## Engineering Referral Response

<b>Application Number:</b>	DA2024/0487
<b>Proposed Development:</b>	Alterations and additions to a dwelling house including a new garage and driveway
<b>Date:</b>	24/05/2024
<b>To:</b>	Anne-Marie Young
<b>Land to be developed (Address):</b>	Lot 2 DP 1015508 , 139 Lagoon Street NARRABEEN NSW 2101

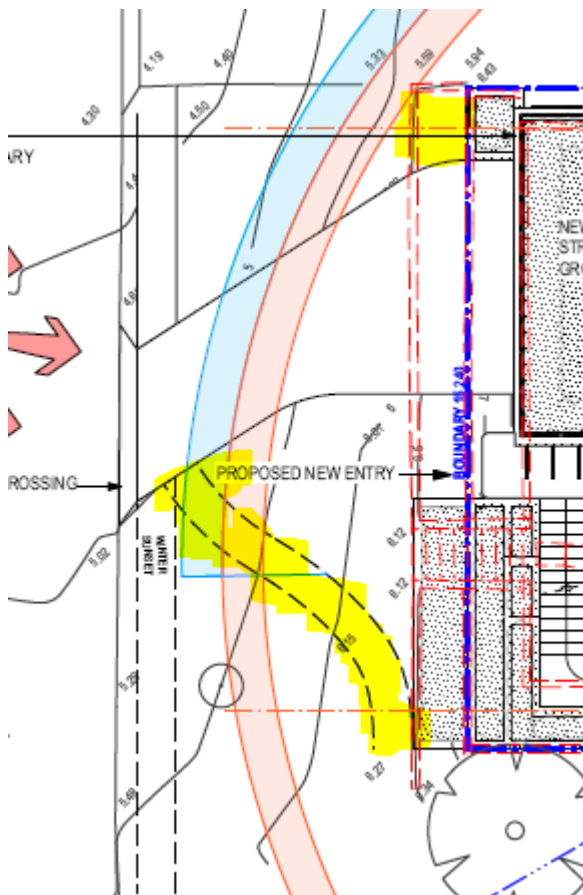
Insufficient information has been provided with regard to the proposed access driveway. The proposed profile cuts into the existing slope of the road reserve which will impact the existing footpath at the top of the road reserve. The architectural plans by MHDP Architects seems to indicate an alternate footpath location however, no details are provided as to how the footpath section north of the proposed driveway (located near the top of the road reserve) will be connected with the section to the south which is proposed near the back of kerb. Refer to snapshot below:

Additionally the architectural plans referenced in the Geotechnical Report by White Geotechnical Group, dated 18/1/2024 shows a different layout for the proposed vehicular crossing.

- Engineering long-section at both edges and centerline of the proposed access driveway to the proposed garage and demonstrate compliance with AS2890. 1. The driveway shall incorporate one of Council's standard vehicle crossing profiles.
- Clarification regarding any changes to the footpath.
- Cross sections along the road reserve are to be provided.
- Updated geotechnical report assessing the current layout of the proposed driveway
